PLANNING COMMISSION STAFF REPORT EXHIBIT "A" FINDINGS OF FACT

Public Hearing Date: January 13, 2015
Date of Report: January 6, 2015
Application Number: 2014-39-NR Natural Resource Permit

Application/Proposal: A request to consider a natural resource review to permit major site grading and wetland fill in the north portion of site and natural resource enhancements and wetland creation in the southern portion of the of the site.

Proposed Future Site Development on Developable Portion (north of wetland to the South) and Buffer Area (Figure 5)

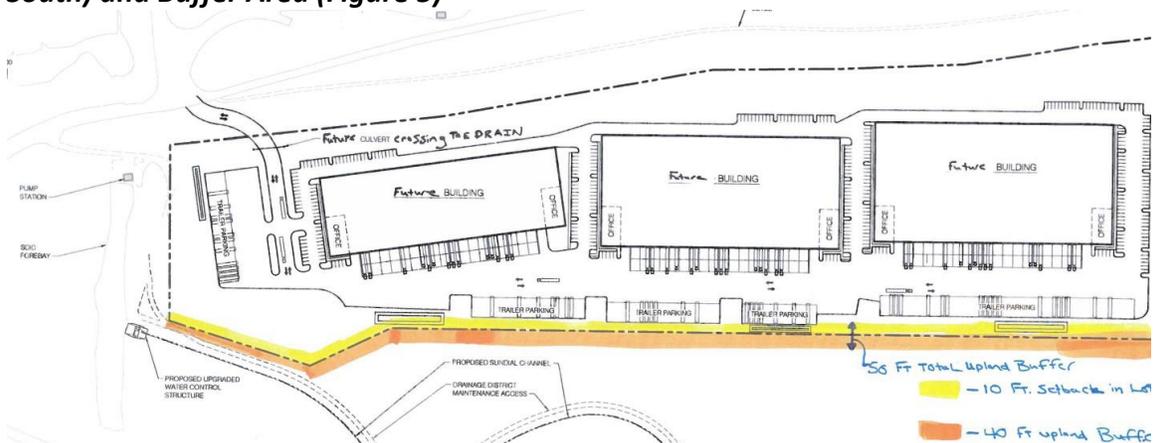
As requested in the project proposal and pursuant to Condition # 31 of the DSL Letter of Authorization located (see Tab I, in Exhibit B) the applicant has requested the city preliminarily approve ten (10) feet of the required 50 foot upland buffer associated with wetland N to be located within a 10 foot side yard setback internally within the lot.

Also as part of this proposal the applicant also requests the City allow 20% of the upland buffer within the setback to contain water quality swales for the purpose of stormwater management. Due to site constraints such as existing utilities and the levee described in the existing conditions section of this narrative the future development lot must be graded to drain towards wetland N. Wetland N ultimately drains into the SDIC pump station located along the western boundary of the site. Prior to conveying stormwater into wetland N, it must be treated, detained and released in a controlled manner. This request would allow the buffer within the lot landward of the top of the graded slope within the future development lot to be utilized for both buffer and stormwater management and create more certainty for a marketing the lot to a prospective developer or site selector who will ultimately purchase develop the lot.

Installation of required storm management facilities are a Type III review process per FMC 19.106.040(B) Table. Since this is application is a Type III review the City will allow up to 20% of the upland buffer within the 10 foot setback (as shown on Figure 5 above) to contain water quality swales for the purpose of stormwater management. The applicant will have to submit a stormwater management plan for future site development that meets all applicable City codes.

Up to 20% of the upland buffer within the 10 foot setback (as shown on Figure 5 above) may contain water quality swales for the purpose of stormwater management. The applicant will have to submit a stormwater management plan for future site development that meets all applicable City codes (Condition 7).
